**CITY OF PORT LAVACA – CITY HALL MASTER PLAN
PHASE 3 – INTERIOR RENOVATIONS AND SITE WORK**
202 N. VIRGINIA ST.
PORT LAVACA, TEXAS 77979
PROJECT #1043-1123

ADDENDUM NUMBER ONE

NOVEMBER 1, 2024

A1.1

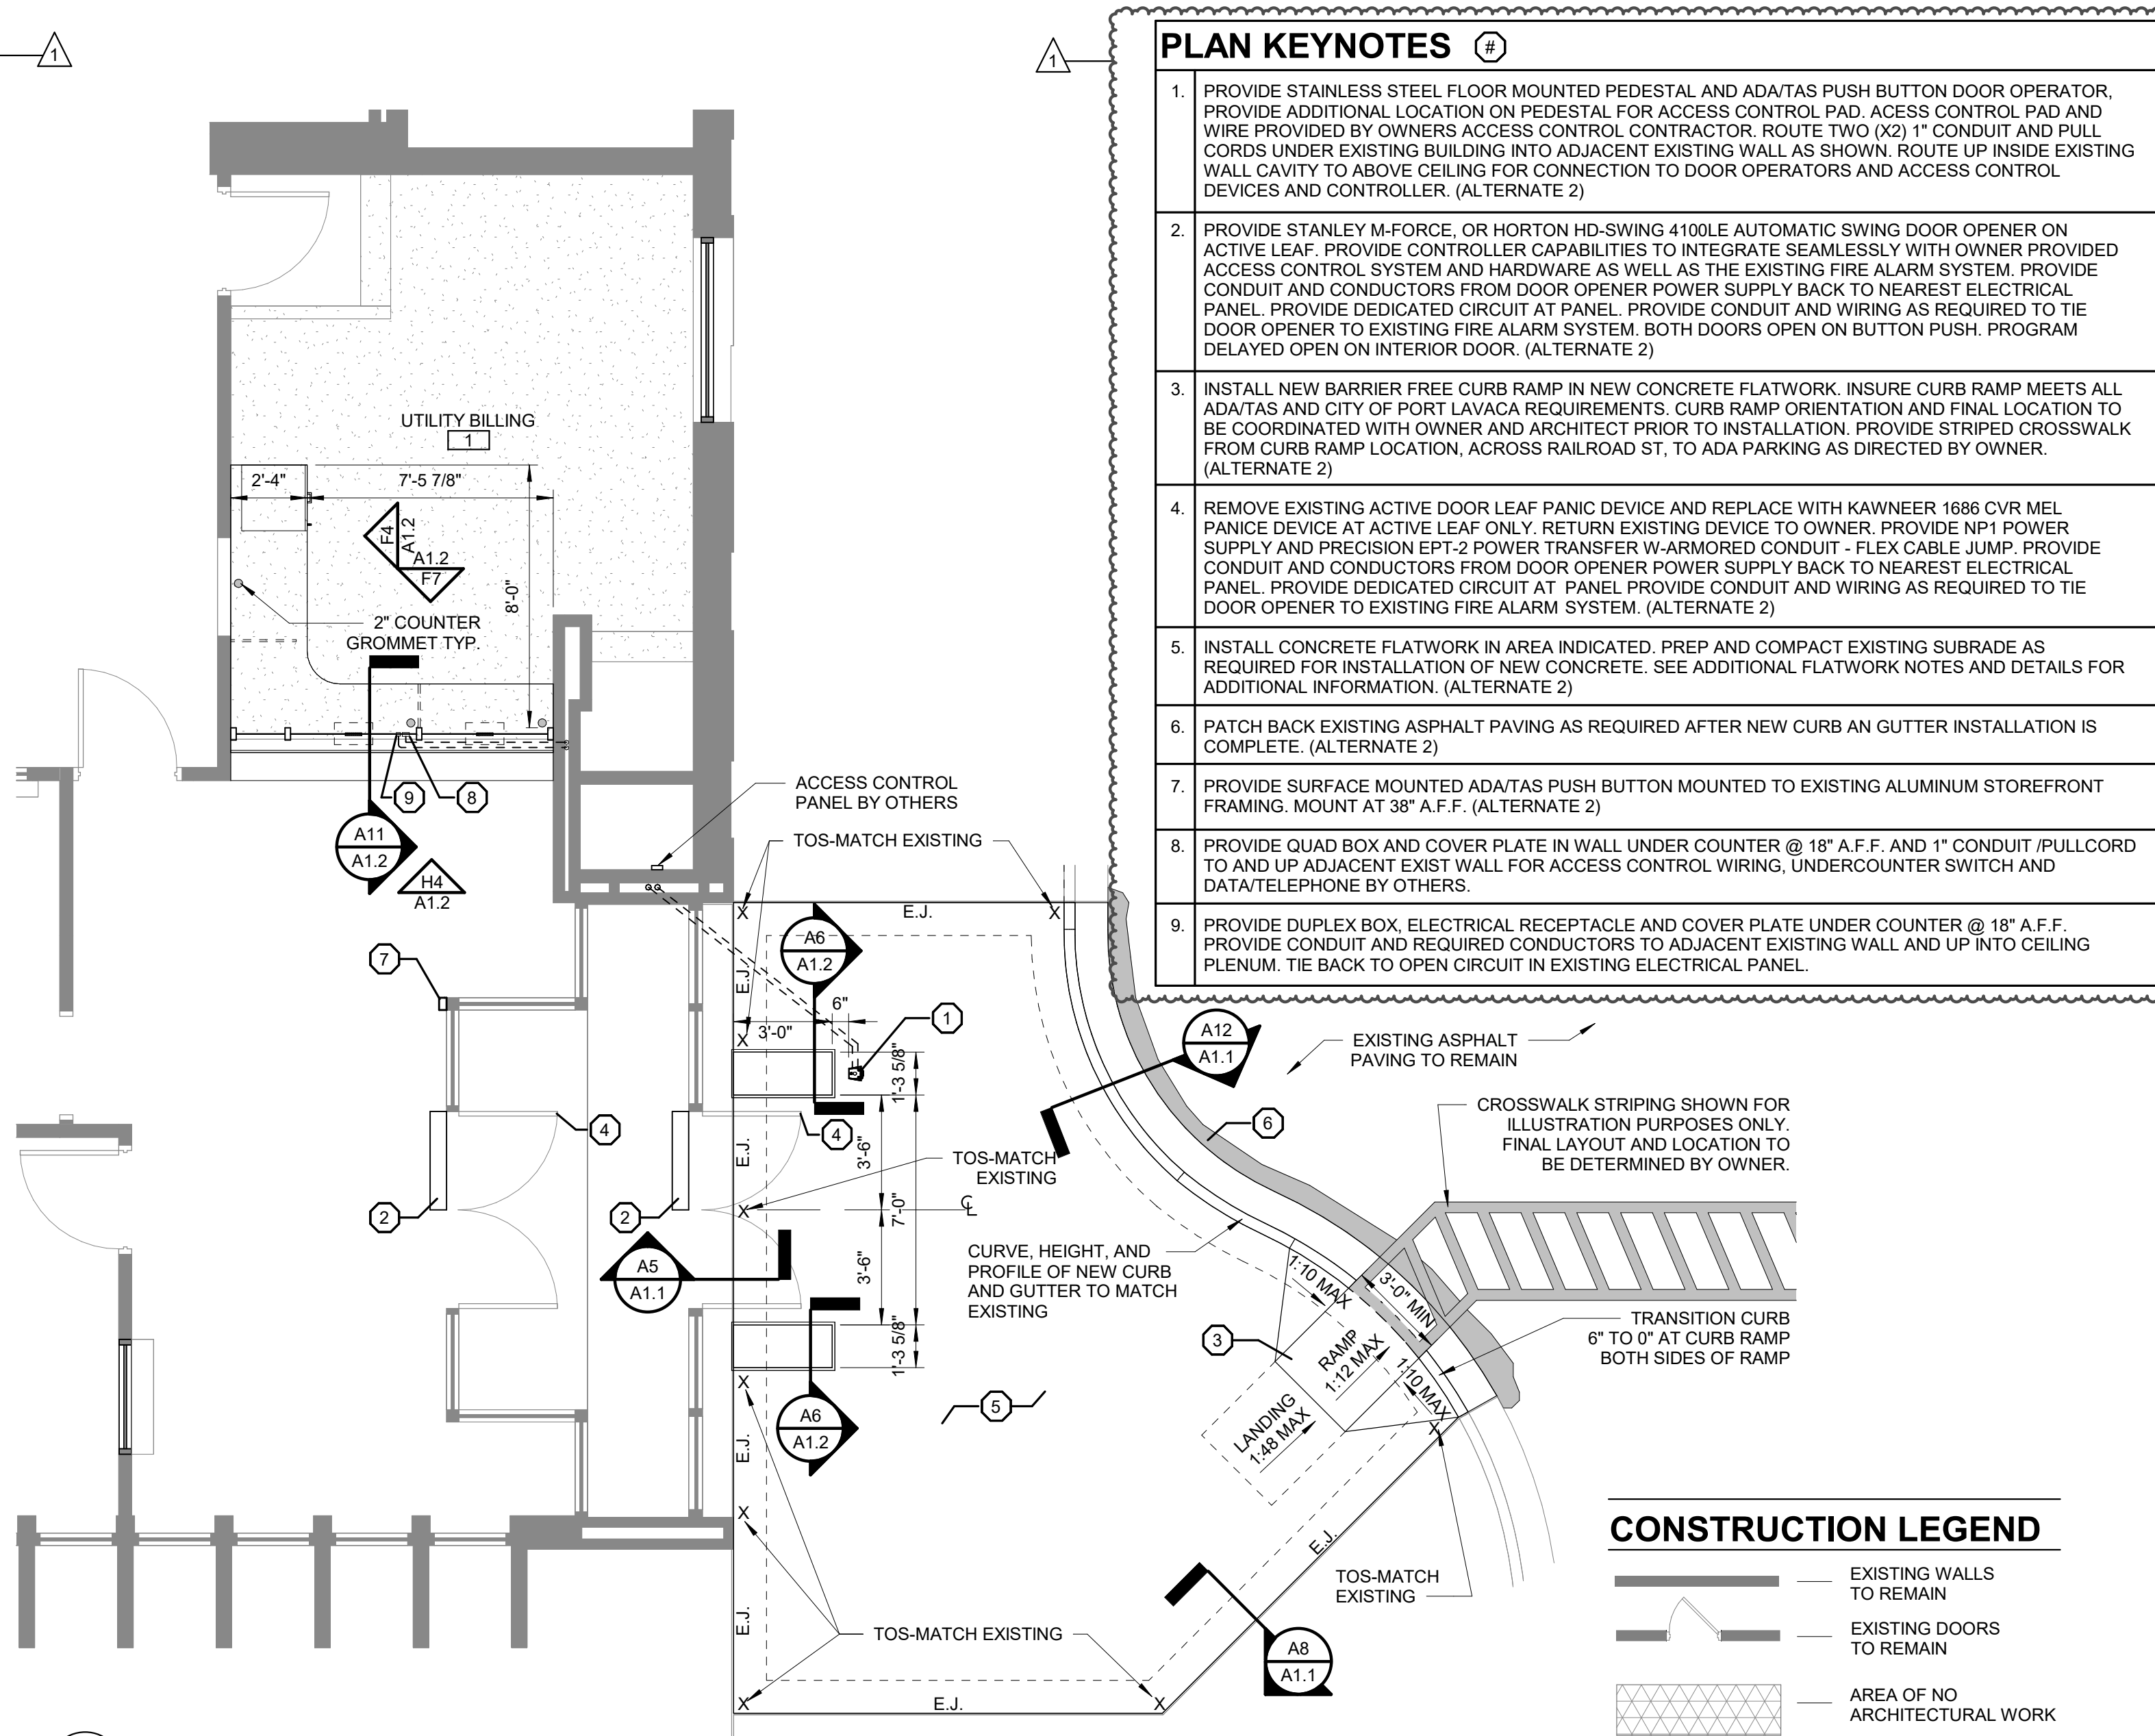
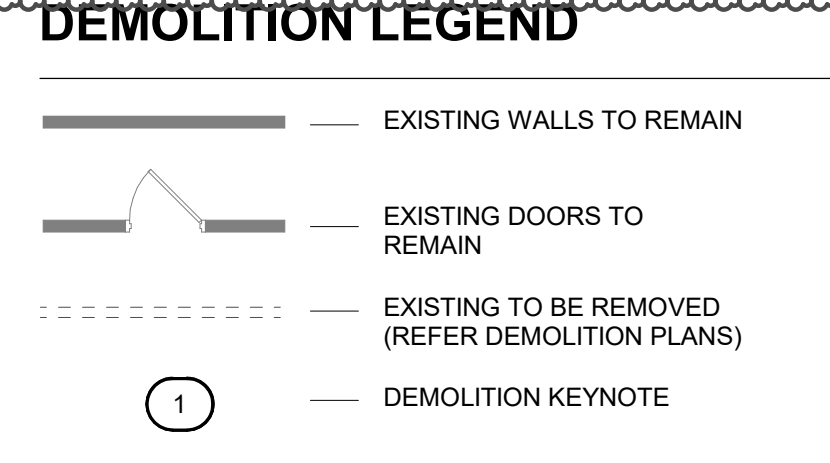
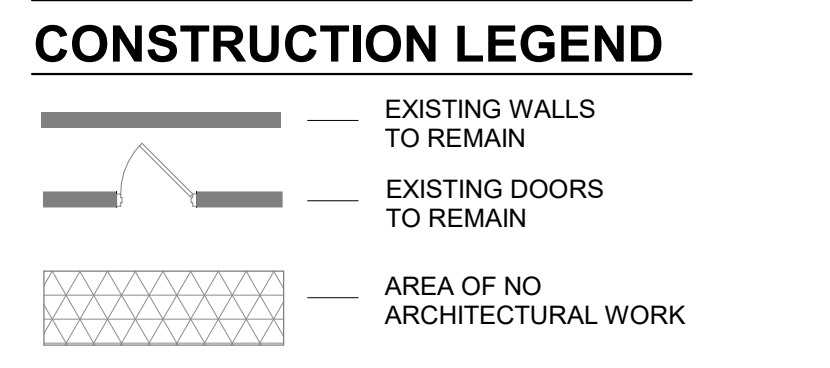
1. A1.1 DEMO PLAN, FLOOR PLAN, AND WINDOW ELEVATIONS
2. A1.2 RCP, WALL SECTIONS & DETAILS
